Working Party on Passive Safety

Fifty-fifth session

Geneva, 19–23 May 2014

Report of the Working Party on Passive Safety on its fifty-fifth session

"Figure 1
Standard seat belt configurations

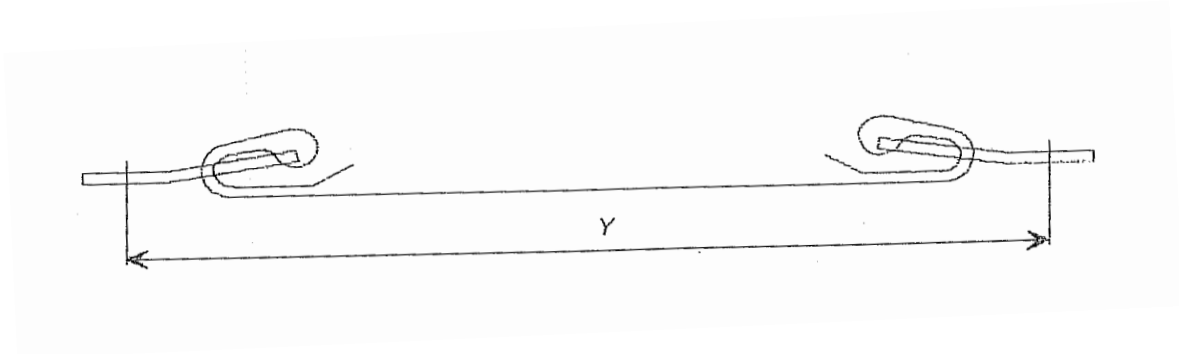
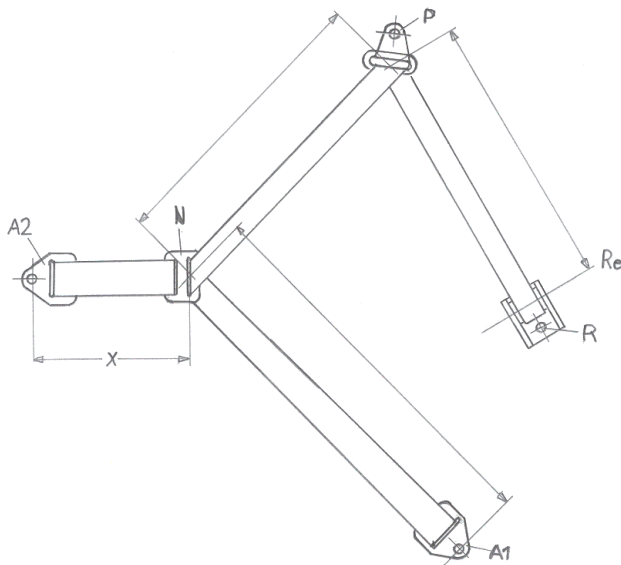
"2. The three-point retracting belt has the following rigid parts: a retractor (R), a pillar loop (P), two anchorage points (A1 and A2) (see Figure **1b**)...

The value of X in Figure **1b** below..."

"5. The two-point static belt as shown in Figure **1a** consist of ...

6. ...The value of Y in Figure **1a** is ..."

Figure 1, amend to read:

"Figure 11
Example of marking of HIC1000 zone and HIC1700 zone

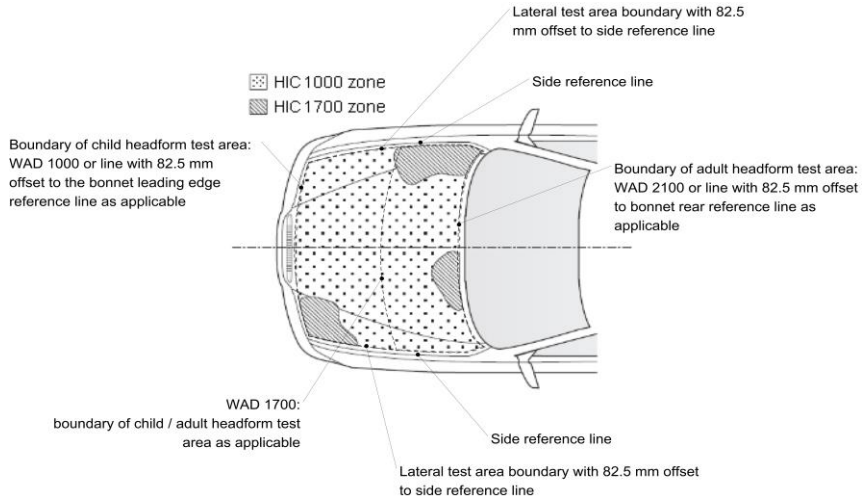
Annex 5, Figure 11, amend to read:
